UNITED STATES PATENT AND TRADEMARK OFFICE

APPLICATION NO.	FILING DATE	FIRST NAMED INVENTOR	ATTORNEY DOCKET NO.	CONFIRMATION NO.
09/729,443	12/04/2000	Steven T. Jaffe	BP1235	6265
51472 7590 09/24/2007 GARLICK HARRISON & MARKISON P.O. BOX 160727 AUSTIN, TX 78716-0727			EXAMINER TORRES, JUAN A	
			ART UNIT 2611	PAPER NUMBER
			MAIL DATE 09/24/2007	DELIVERY MODE PAPER

Office Action Summary

DETAILED ACTION

Figure 3

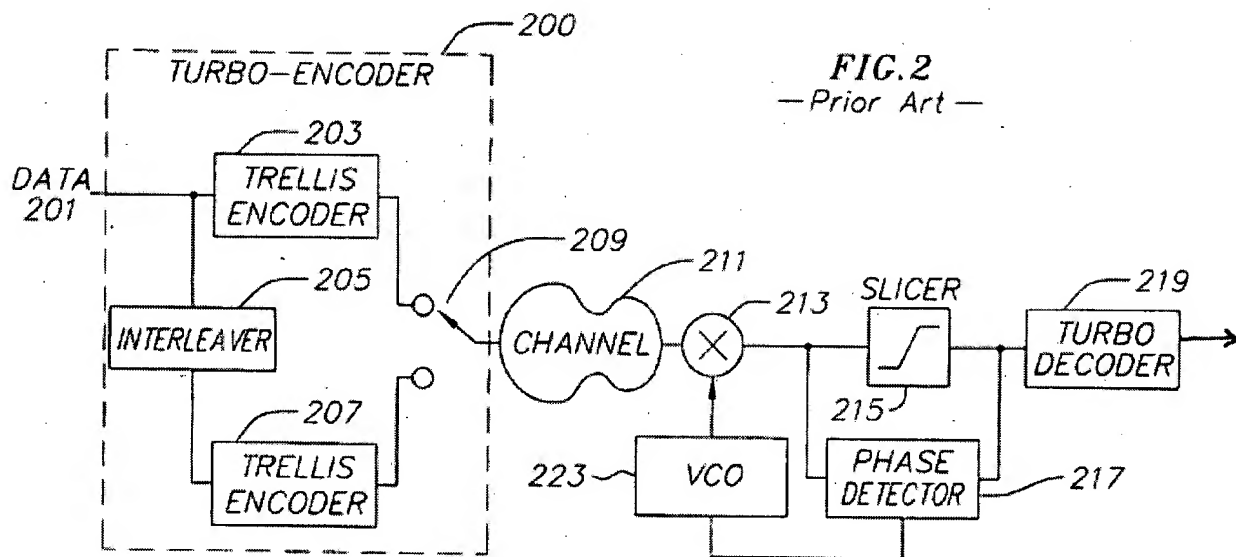
The drawings are objected to because Figures 3 and 4 are of not enough quality; it is suggested to send new figures 3 and 4 in the same quality that figures 1 and 2 (see below). Corrected drawing sheets in compliance with 37 CFR 1.121(d) are required in reply to the Office action to avoid abandonment of the application. Any amended replacement drawing sheet should include all of the figures appearing on the immediate prior version of the sheet, even if only one figure is being amended. The figure or figure number of an amended drawing should not be labeled as "amended." If a drawing figure is to be canceled, the appropriate figure must be removed from the replacement sheet, and where necessary, the remaining figures must be renumbered and appropriate changes made to the brief description of the several views of the drawings for consistency. Additional replacement sheets may be necessary to show the renumbering of the remaining figures. Each drawing sheet submitted after the filing date of an application must be labeled in the top margin as either "Replacement Sheet" or "New Sheet" pursuant to 37 CFR 1.121(d). If the changes are not accepted by the examiner, the applicant will be notified and informed of any required corrective action in the next Office action. The objection to the drawings will not be held in abeyance.

Fig. 1. Classical concatenation of a carrier recovery loop and a Turbo-decoder.

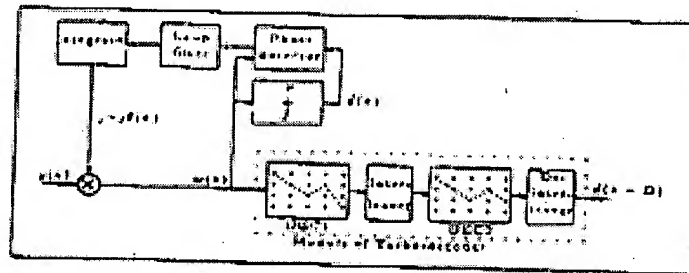
The reference used by the Examiner under statutory bar 102(b) of 35 USC (Mottier "Influence of tentative decisions provided by a Turbo-decoder on the carrier synchronization: Application to 64-QAM signals", COST 254 Workshop on Emerging Techniques for Communication Terminals, Toulouse France July 7-9, 1997, pages 326-330) present the same idea: Figure 1 present the use of the classical slicer in the carrier synchronization, similar to the figure 2 of the present Application
